**Subject:** DA2010/0697 – Urban Design Referral Comments

We refer to your request to provide comments on DA2010/0697 proposed at 22-26 Albert Street, Freshwater. Strategic Planning have not undertaken a detailed assessment of this development application. This memo summarises our comments on broad urban design issues identified with the development.

# URBAN FORM STUDY

Shadow cast at 12noon Winter - 21st June

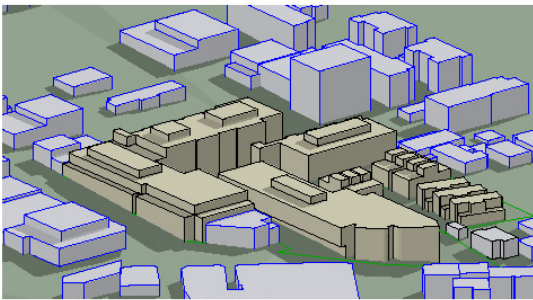
2. The retail plaza proposed is in shade during winter noon time i.e. east-west orientation. The plaza has been included in the landscape area calculation as a hard paved area (9.5% of H2 site area) and is the major public open space proposed in the development. The design should optimise solar access to contribute positively to public and residence amenity.

Site Plan with AHD levels

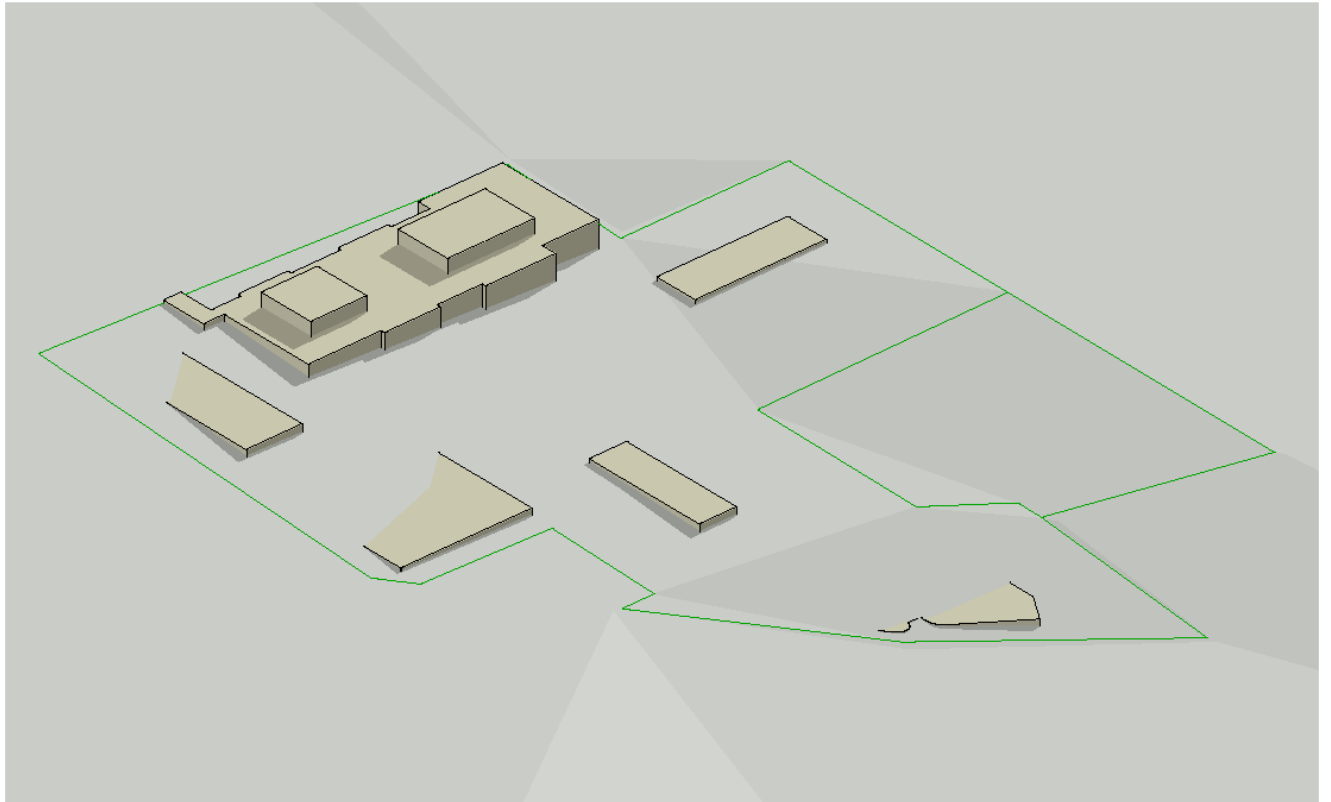
3. Building height control of 3 Storey is exceeded by 1 and 2 storeys in Block A and B respectively. Building D exceeds the height limit of 11m by 1.5m. These non-compliances will set precedence for future developments to follow.
